Wairau Blue-Green Network Stage 1 - A F Thomas Park

Concept Feasibility Report - Appendices C to G

Revision 1 | 06 August 2025

Subject: AF Thomas Park Concept Options Technical Assessment

Figure 2: Output of mounding between drains calculation (by WSP)

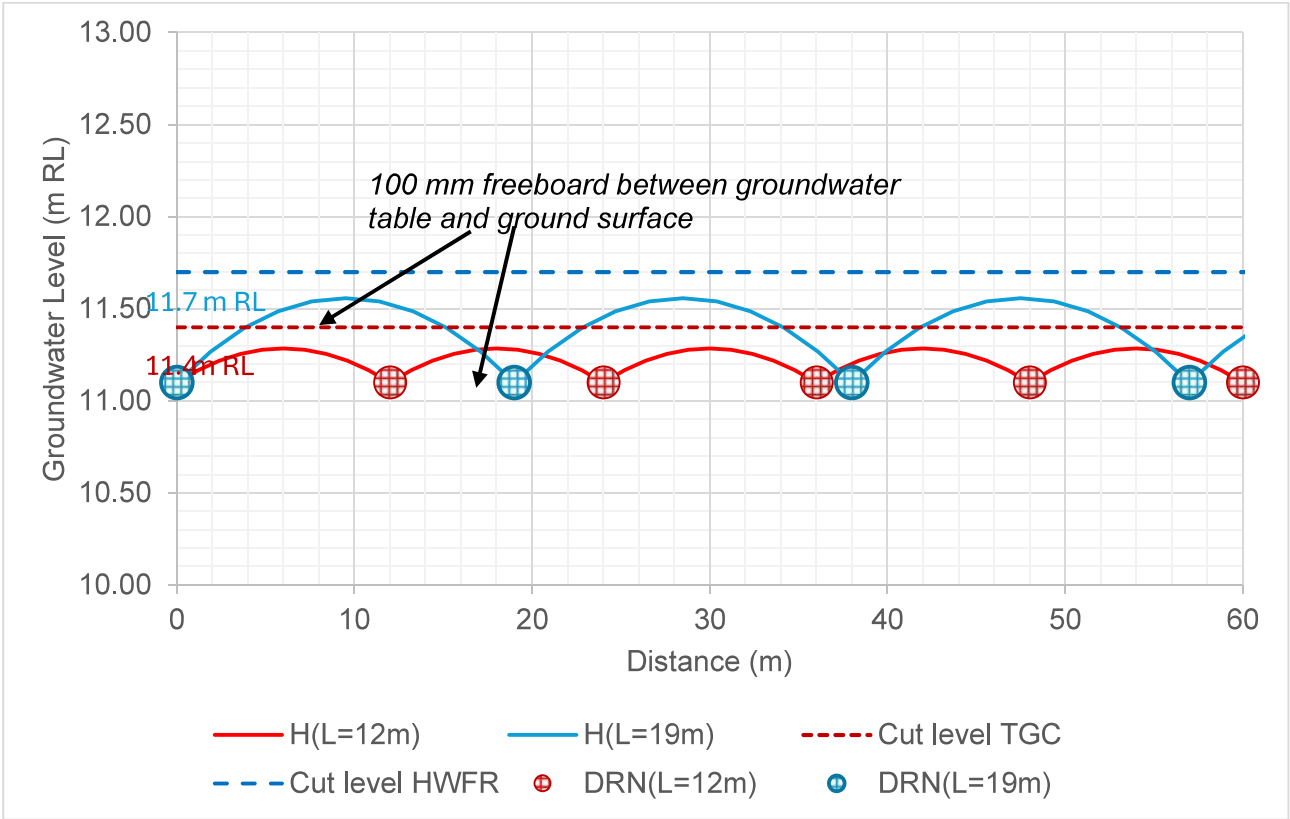
while the TGC would need drains every 12 m (Figure 2). It is important to note that this assumes the drains are equally effective between designs. However, the shallow fall of the TGC drains means these might be less effective, meaning that even more will be needed.

It should be noted this assessment is, by necessity, a simplification. At the upstream end of each proposal it is likely that increased density of drains will be needed as they will be shallower in these areas.
